JUMBO MINING CO.

March 25, 1992
File: DOG32592

RE: Response to Division's letter
January 14, 1992-Second Technical
Review, Permit Amendments, Mizpah
Pit & New Heap Leach Pad, Drum
Mine, M/027/007, Millard Co., UT

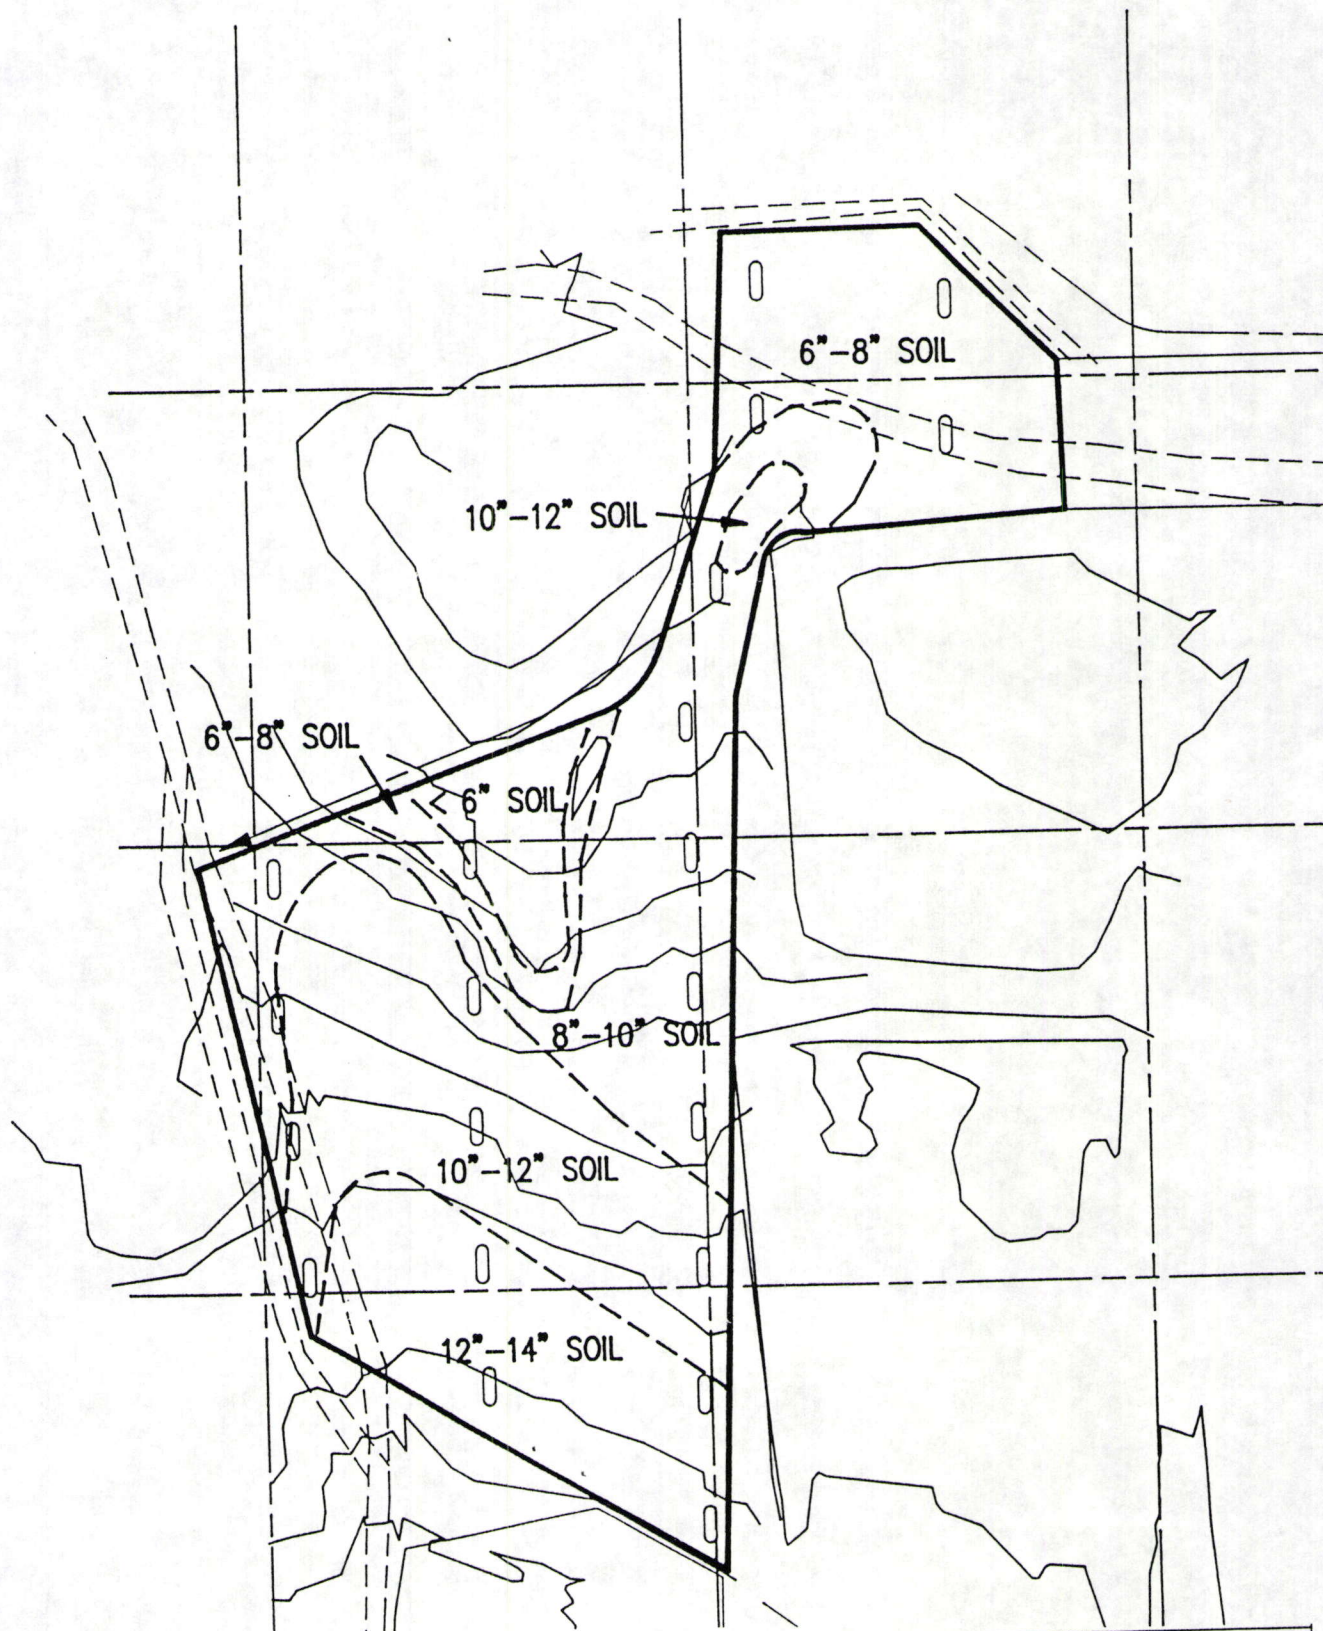
The locations and depths of topsoil are shown in Figure 2-2. Approximately 15,600 yards of topsoil was determined to exist at the new heap area.

Jumbo has stated that topsoil will be applied on top of the new heap to a uniform depth of 6 inches minimum. The source of the topsoil which is shown in Figure 2-2 will be from the new pad area. The volume to be stockpiled will be 15,600 cubic yards. This soil will be used mainly for topsoiling the new heap and any excess will be hauled to the Mizpah area if additional soil is needed there. Current topsoil that has been stockpiled at the Drum Mine by Western States is less than 2,000 yards.
